SYAMA PRASAD MOOKERJEE PORT, KOLKATA

Upgradation of 11kV/415V Substations & allied equipment along with 5years manning and comprehensive maintenance at residential areas of Haldia Township under Haldia Dock Complex, SMP, Kolkata

ADDENDUM - I

QUERIES OF DIFFERENT FIRMS IN CONNECTION WITH THE PRE-BID MEETING HELD ON 27.07.2021

A tentative System Architecture is indicated below:-

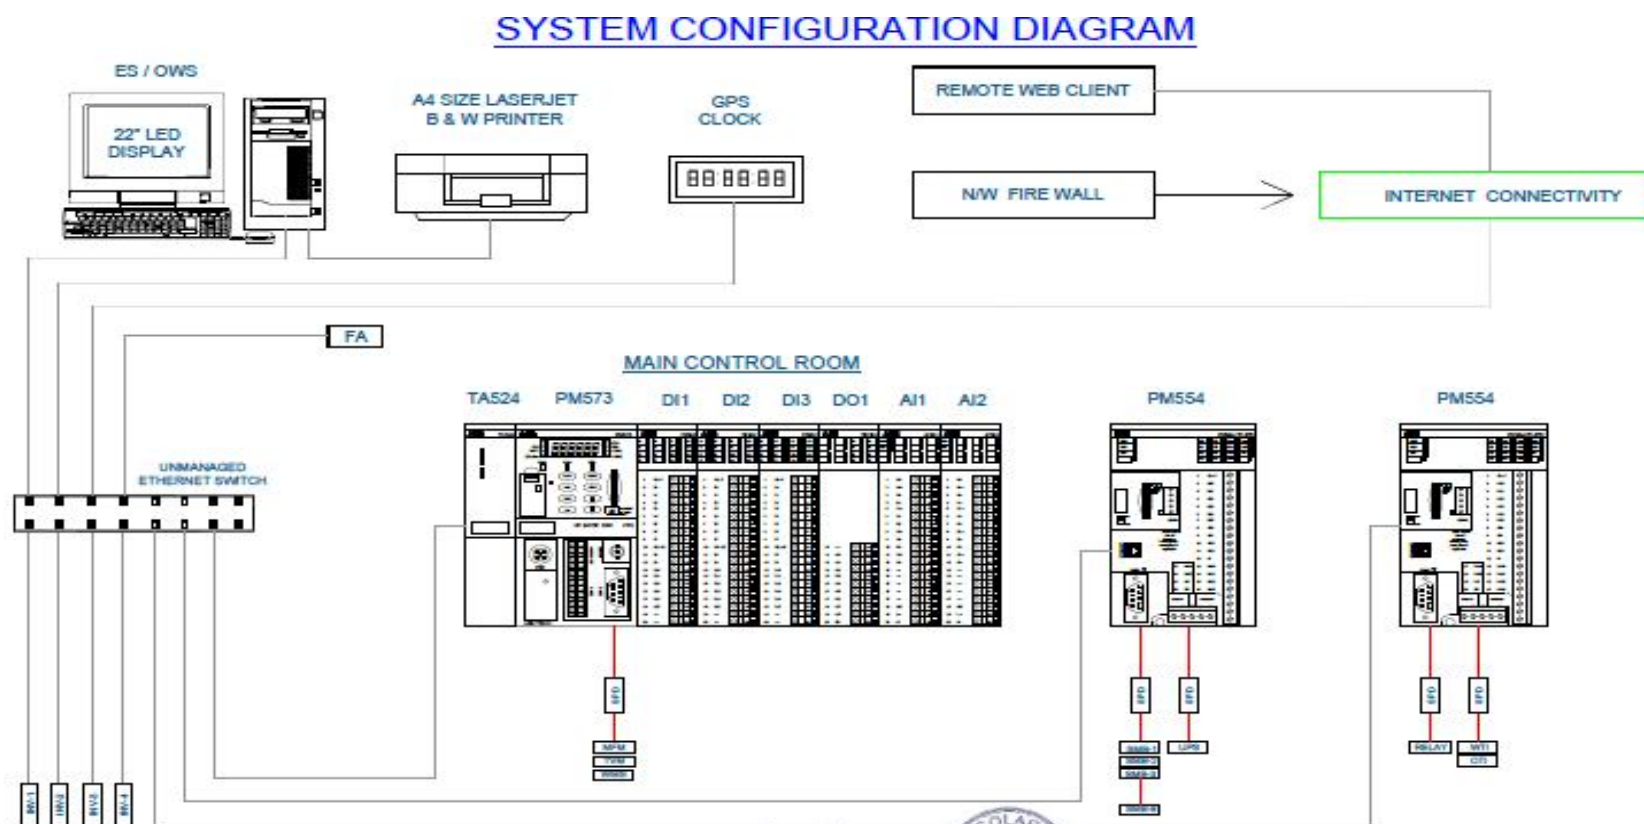
Providing SCADA System at sub-station-3 for operation, control and condition monitoring of HT, LT switchgears and Transformer using Modbus Protocol with necessary provision for connecting balance 6nos. Sub-station at HDC township in future.

SCADA system at main sub-station at SS-3 for monitoring and control of sub-station with Ethernet switches, interposing relay, transducers, network switches. [Job includes SCADA Software and associated Hardware(such as HMI, server, GPS with software, antenna, Laser Printer, Cyber security device Networking equipment , FO cables, Patch Cords, LIU's, Cat-5/Cat-6 Cables, LAN Cable, Twisted cable, 5kVA UPS system, Network switches etc. required for system integration etc.[As per IEC 61850 protocol.]
